Item No. 12.1
Halifax Regional Council
January 14, 2020

SUBJECT: **Appeal of the Decision of the Design Review Committee for Case 22511:
Substantive Site Plan Approval for 1144, 1148, and 1150 Barrington Street,
Halifax**

CASE 22511 **SITE PLAN**
 THE OLYMPIC 1144 - 50 BARRINGTON ST.

CASE 22511 **SOUTH ELEVATION**
THE OLYMPIC 1144 - 50 BARRINGTON ST.

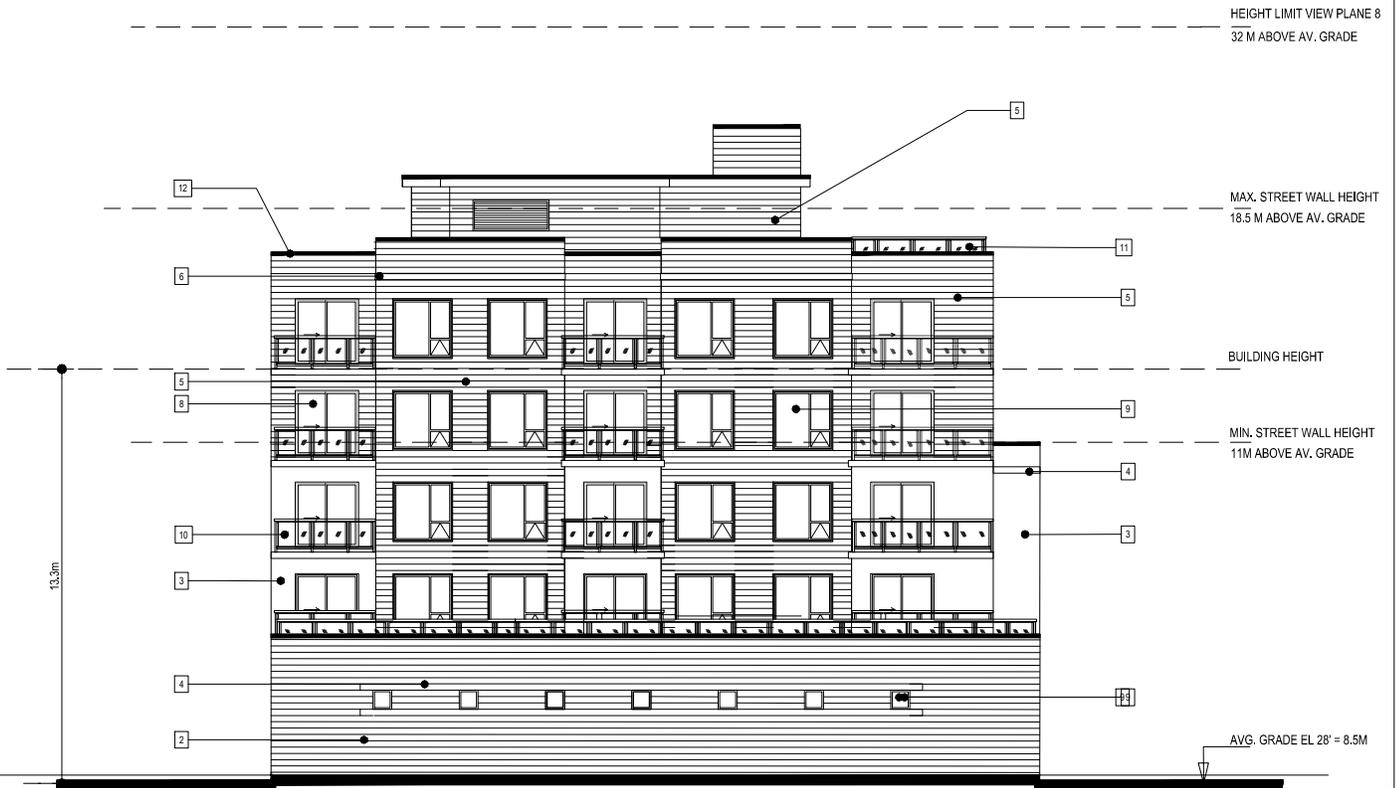
2. west elevation: of levels 2 & 3 a setback of 7.1 metres (~25.7% of lot width) is proposed from the south property line to provide suitable interaction with the low-density residential uses; and
3. south elevation: on levels 2 & 3 the building setbacks creating a west face that requires a setback of 10.97 metres (~39% of the lot width) from the west property line to provide the balconies an appropriate separation distance from the property line.

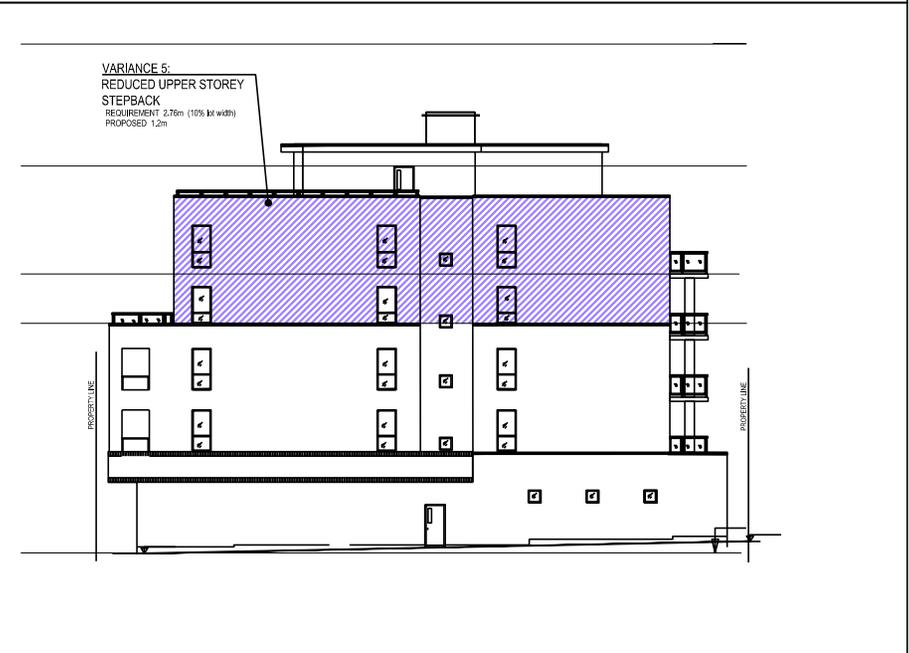
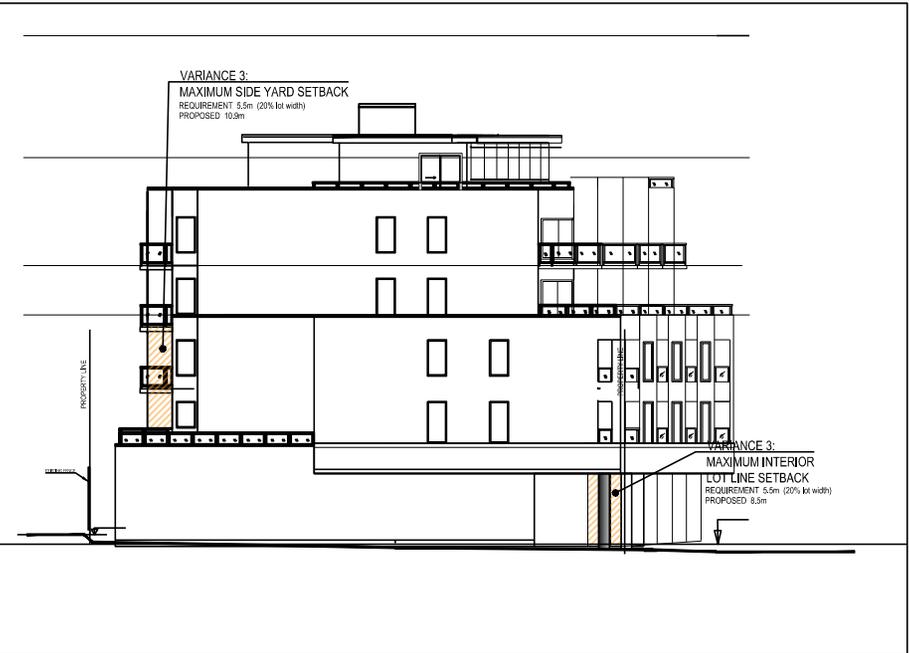
Non Compliance: There is one area of non-compliance. On North façade, the step back of upper floors 4 and 5 is 1.2m from the interior lot line.

3.6.6 (a) Generally the Design Manual requires upper storey setbacks to ensure adequate separation distances are maintained to abutting structures, As there is an open parking lot abutting the north property line, the reduced setback dimension on the north wall has minimal impact on the already substantial separation distance. A change in materials for the top two stories is used to mark the transition from low rise to medium rise on the north building wall

3.6.6 (b) The modest site dimensions result in combined with an efficient configuration of the service core intrudes in the required setback of the top two residential floors. The proposed building is only 5 floors, with only two upper floors above the three storey streetwall. The entire north façade is set back 4 feet from the interior lot line, The impact of the reduced setback is mitigated by the fact that the building on the adjacent site is set back approximately 12m from the common lot line and the adjacent side yard is used for surface parking.
